July 1, 2004
9704-PFS-017

Enclosures: GT STRUDL Program Report Forms 2004.1 through 2004.9

GTSTRUDL Program Report Form

GPRF No.: 2004.1

Incorrect Figure 3.14-3

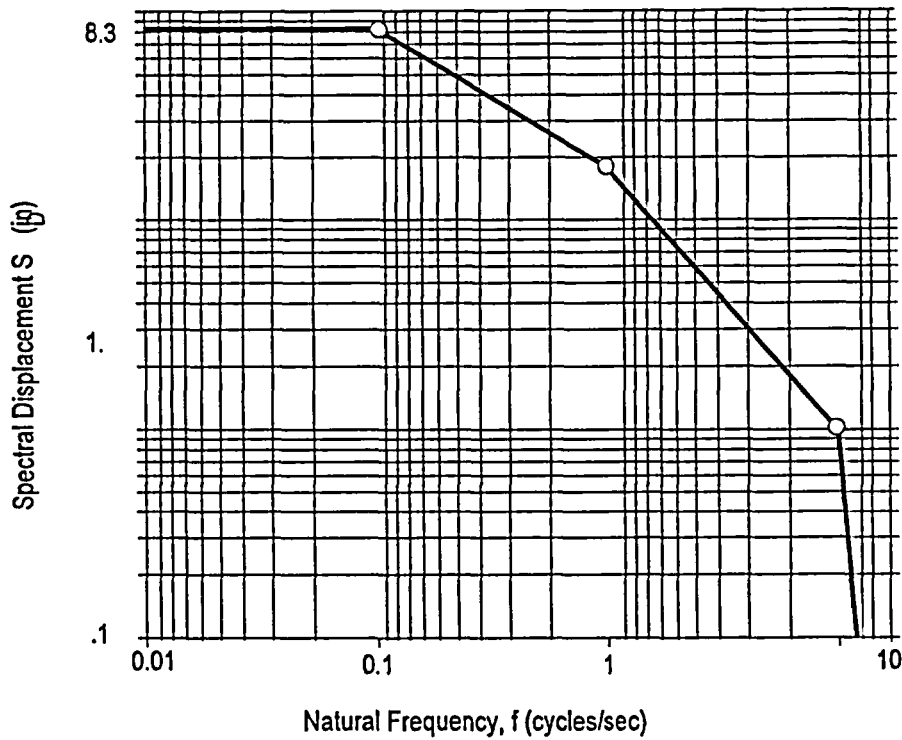
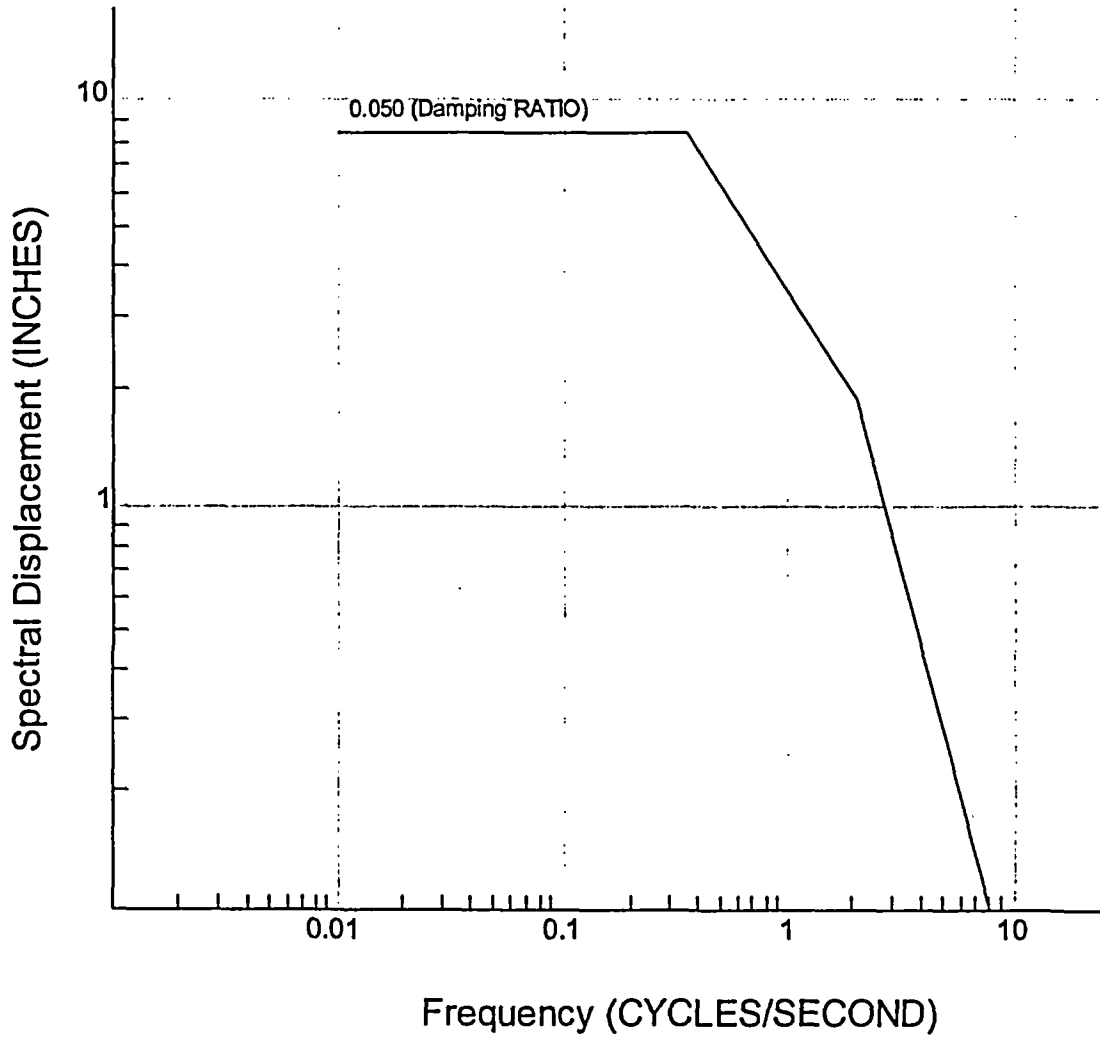
Figure 3.14-3, Section 3.14, GTSTRUDL Verification Manual, Volume 1, depicting an X-Y plot of response spectrum file EQUAKE, is incorrect. The incorrect figure is shown below, followed by a correct figure:

Correct Figure 3.14-3
